2021-08-13

**REQUEST FOR PROPOSAL
ENGINEERING SERVICES FOR THE
INSTALLATION OF FIRE SPRINKLER SYSTEMS AT THE
AFRICAN RAINFOREST AND INDO MALAYA PAVILIONS
RFP 24 (2021-07)**

ADDENDUM 3

A3.07

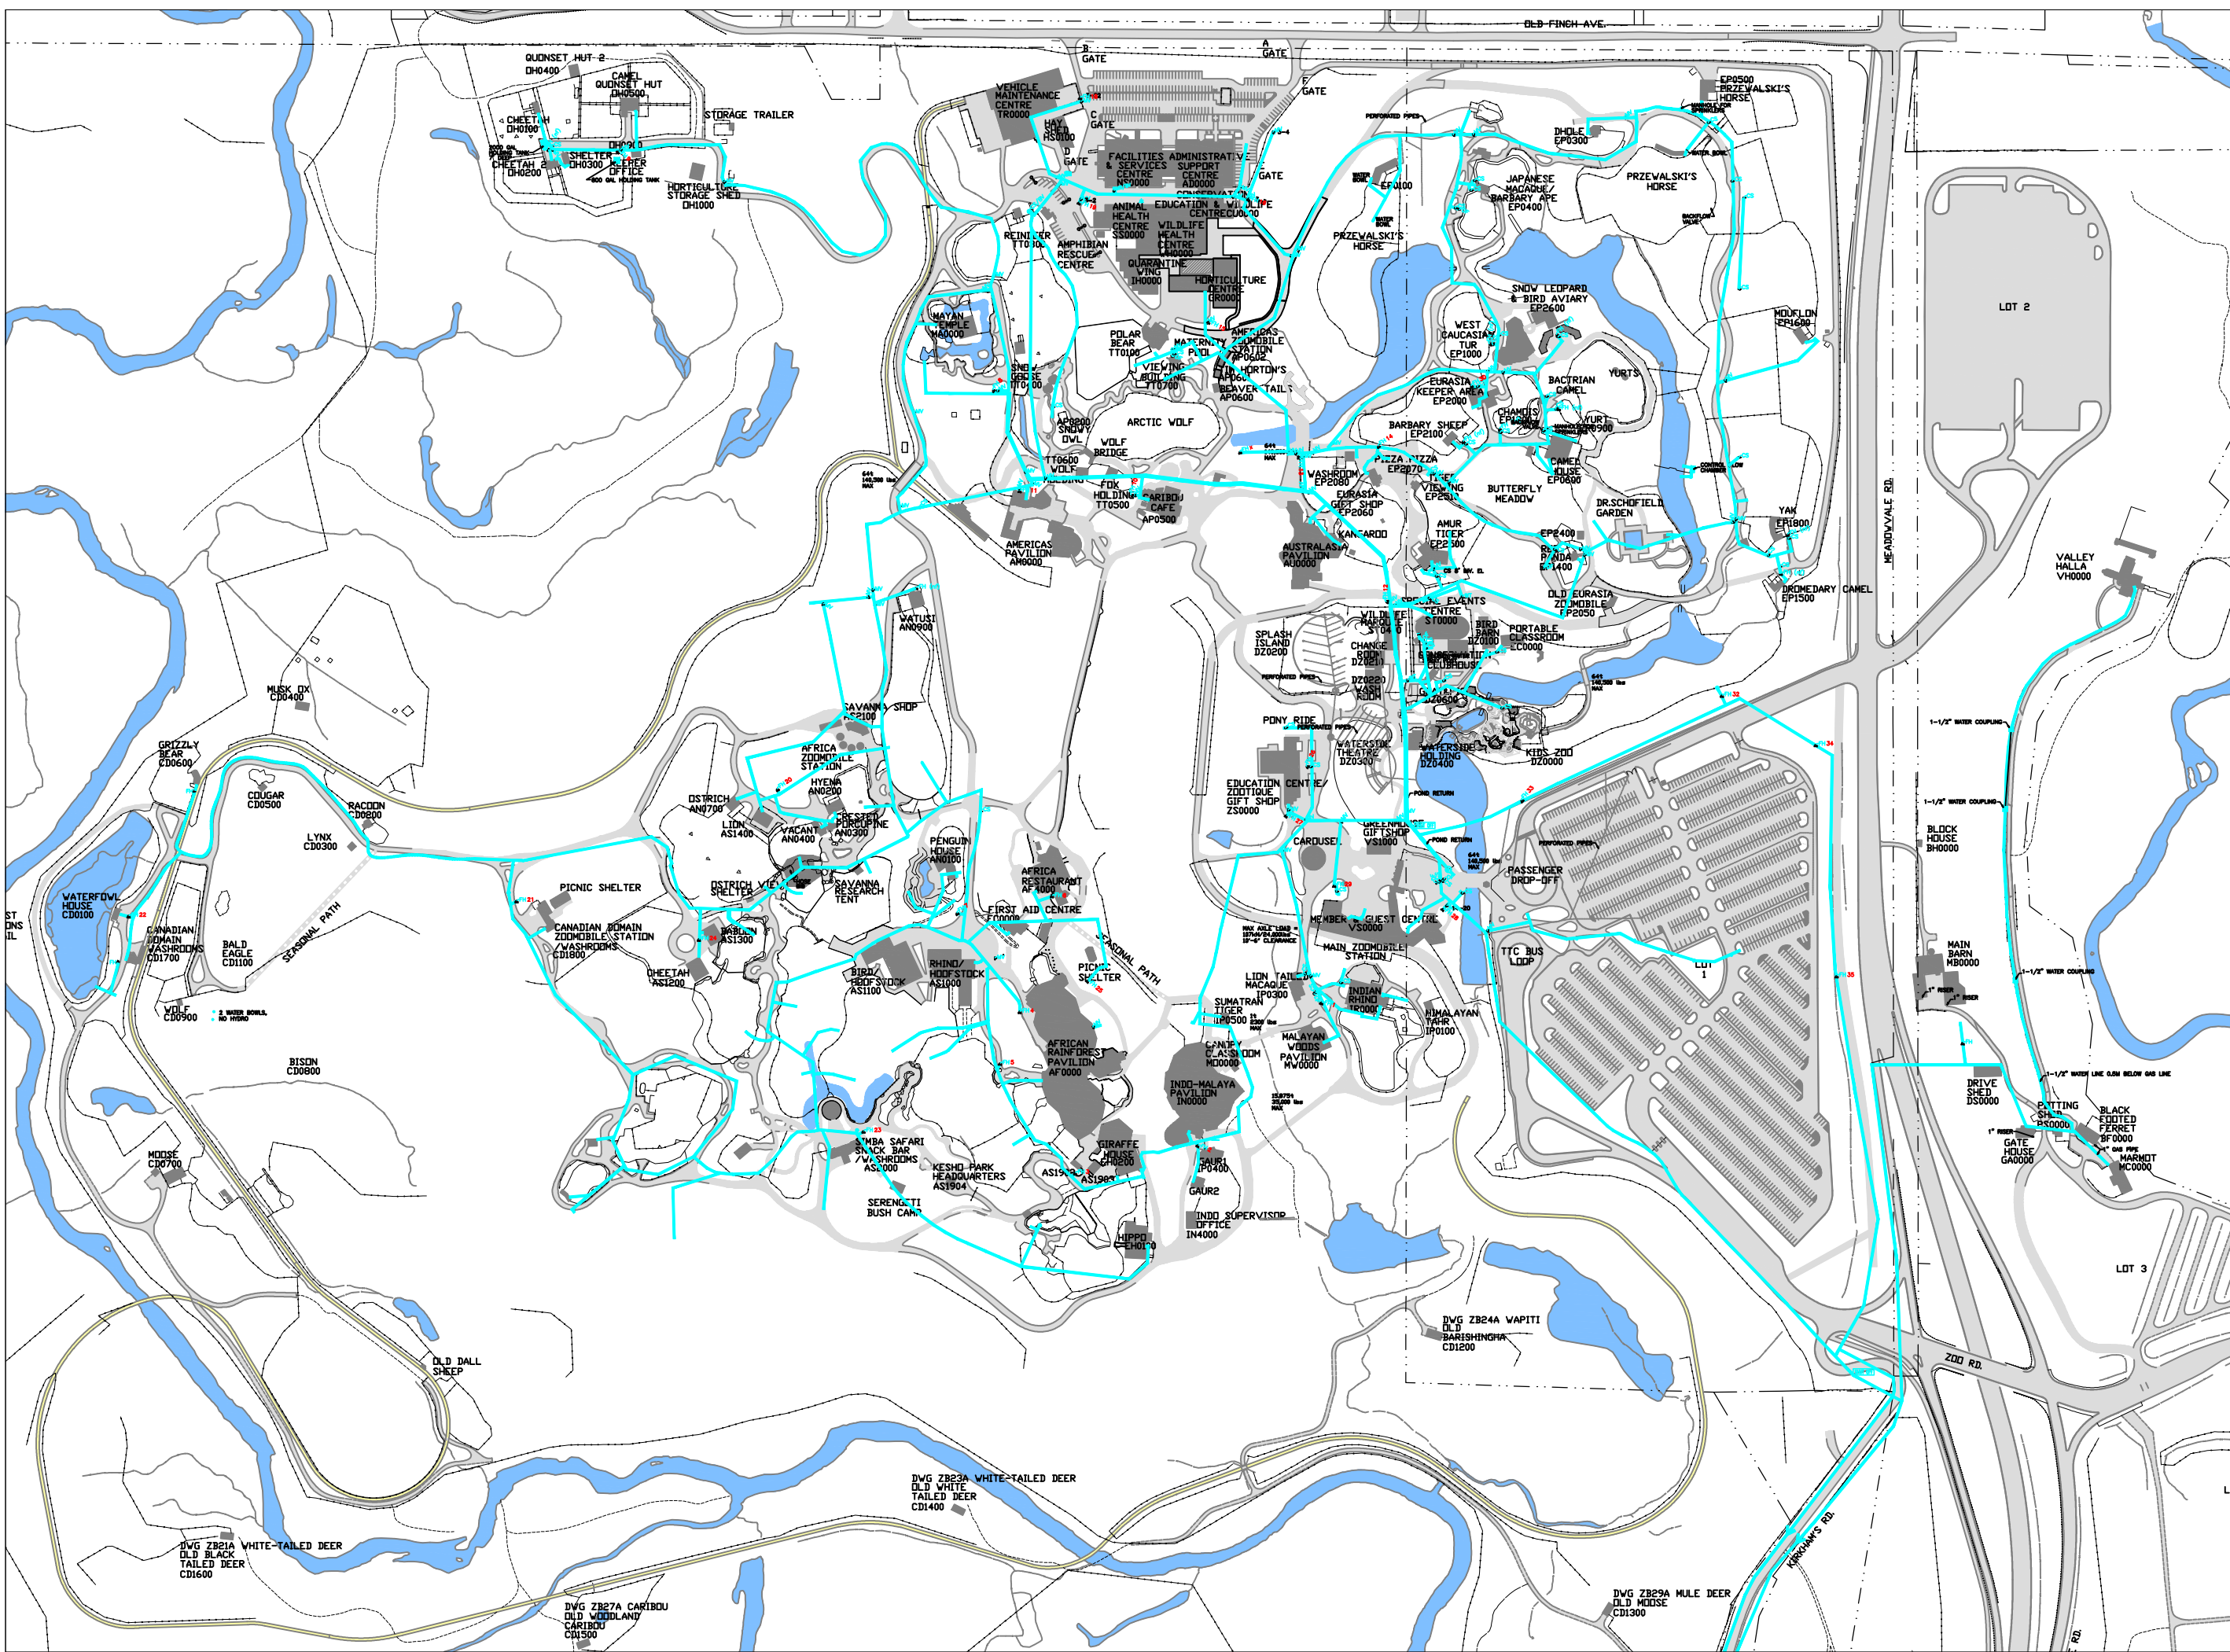
Are water servicing plans available for this site?

Yes. See attached drawing.
